Office Action Summary	Application No. 10/502,416	Applicant(s) GREUB, DANIEL	
	Examiner Erin D. Chiem <i>EDC</i>	Art Unit 2883

DETAILED ACTION

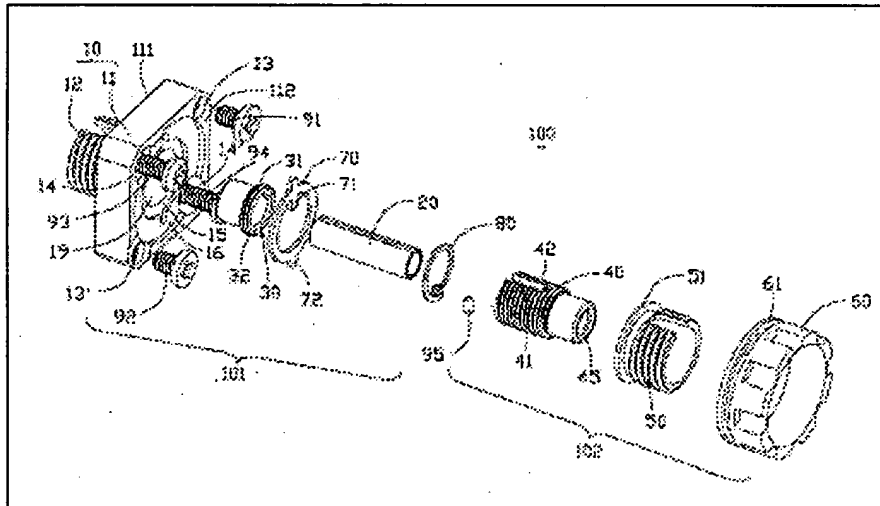
Claim 17 and 36 are rejected under 35 U.S.C. 102(e) as being anticipated by Wu et al. (US 6,666,586 B2, hereinafter “Wu”). Wu discloses in Fig. 5, A sleeve mount assembly (100) comprising a sleeve mount (111) having an interior for accommodating and securing a

cylindrical sleeve (40) having a longitudinal slit (41), the sleeve mount assembly further comprising optical plug-in connections (12, 50) for accommodating ferrules of two optical plug-in connectors introduced from opposite directions, the sleeve mount having means for securing the sleeve against rotation about a sleeve axis (70, 71, 72, 151) wherein the means for securing are arranged in a central part of the sleeve mount and are restricted to the central part of the

Claims 27 and 37, the two separate accommodating parts are the two connection members (12, 50) wherein the means for securing are arranged and retained between the accommodating parts.

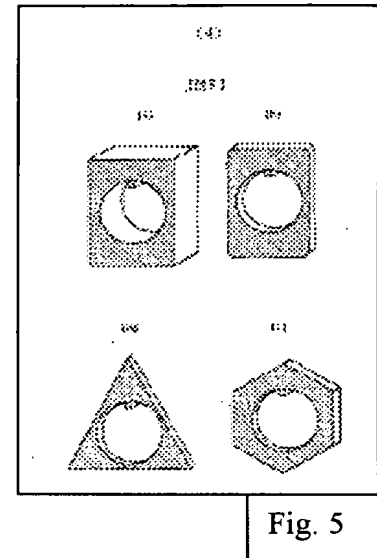
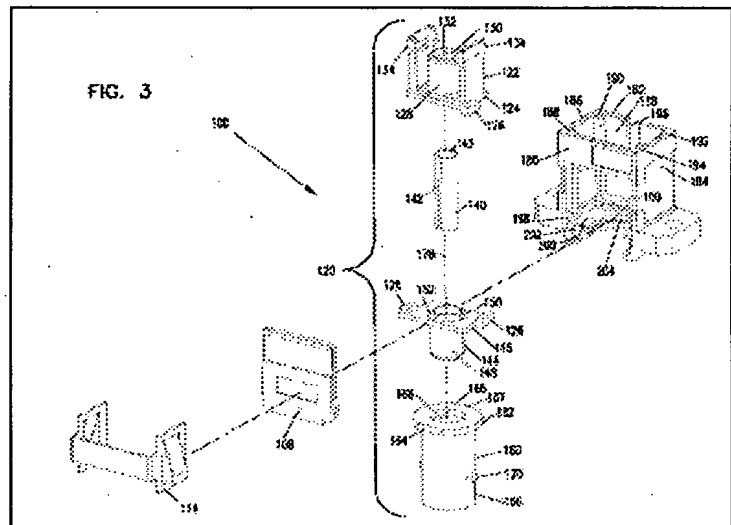
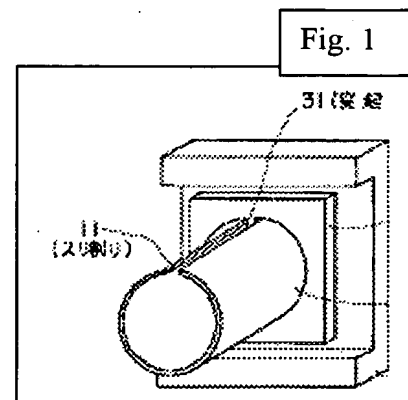
However, Wu does not disclose the accommodating parts are put together, the means for securing comprising a securing plate retained in a rotationally secure manner between the flange parts and engaging in the slit of the slit sleeve by way of a protuberance.

Ishikawa discloses a portion of a connector (Fig. 1) having a securing plate (3) retained in a rotationally secure manner and engaging in the slit of the slit sleeve (11) by way of a protuberance (Fig. 5). However, Wu does not explicitly disclose a second flange which abuts to the first flange (2).

Puetz discloses a connector adapter wherein two flanges abut against one another, similar to the connector disclosed by Ishikawa.

It would have been obvious at the time the invention was made to a person having ordinary skill in the art to the securing plate (Fig. 5) may be used in Wu's adapter as a mean of securing the sleeve from rotation with the

motivation of maintaining alignment to "decrease the fluctuation in the loss by repetitive attaching and detaching" (PURPOSE of Ishikawa patent). Furthermore, Puetz's

reference is applied to explicitly show the functionality of Ishikawa's adapter, wherein Ishikawa does not explicitly show the second abutting flange. **The motivation** for providing a second flange is to latch the two flanges together such that the flange(s) will not slide along the longitudinal direction of the sleeve.
